# CITY OF ALBUQUERQUE

RE: **Matthew Drive Storage**  
**3309 Matthew Dr. NW**  
**Grading and Drainage Plan**  
**Engineers Stamp Date 9/28/16 (H16D147)**

The purpose of this letter is to accompany the attached grading plan. The plan has been revised to address your emailed comments dated 9/28/16. We have included your comments and responded as to how we have addressed your comments

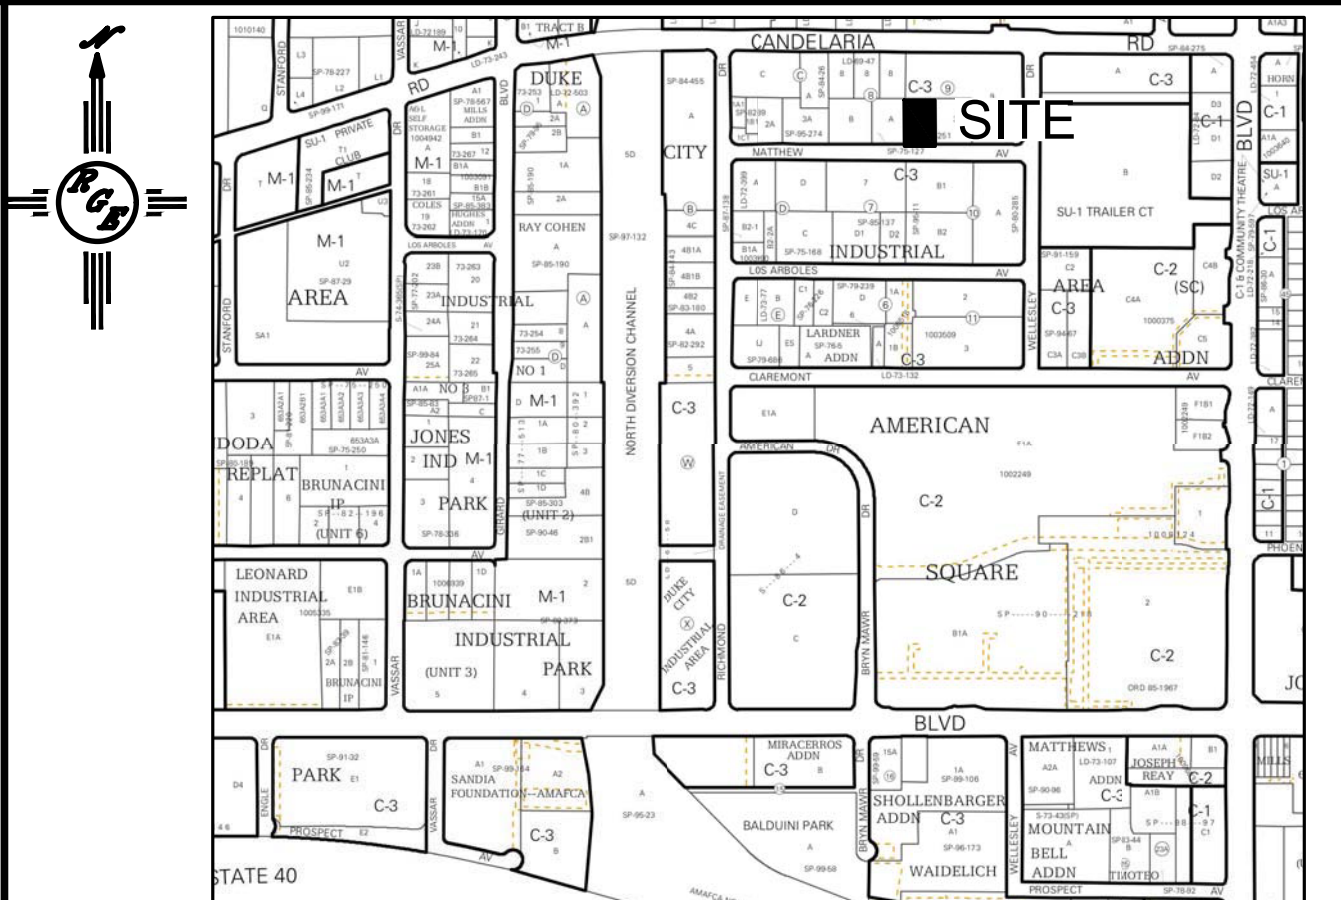
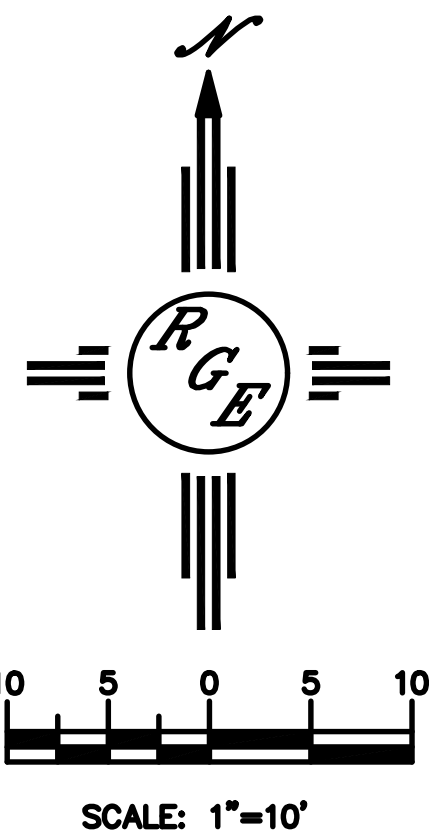
- Enlarge the drainage calcs or provide on a separate sheet with the proper font size. Once submitted the calculations will be checked.  
**We have increased scale of the calculations**

- Provide spot elevations outside the new buildings.  
**We have added spots**
- Statement on sidewalk culvert, add extend passed property line 1 foot.

**We have added note**
- Are the landscaping areas new? Is there a curb at the edge of pavement? Is the entire site paved?  
**The existing site is entirely compacted base course. We are not proposing pavement.**

- Provide a note in the SO-19 notes stating, to contact Jason Rodriguez at 235-8016 for the sidewalk culvert inspection before and after pouring the concrete.

**We have added Jason's contact information and instructions**
- Provide a notes stating, The curb stone for the sidewalk culvert must be removed from joint to joint, no cutting.

**We have added this note**
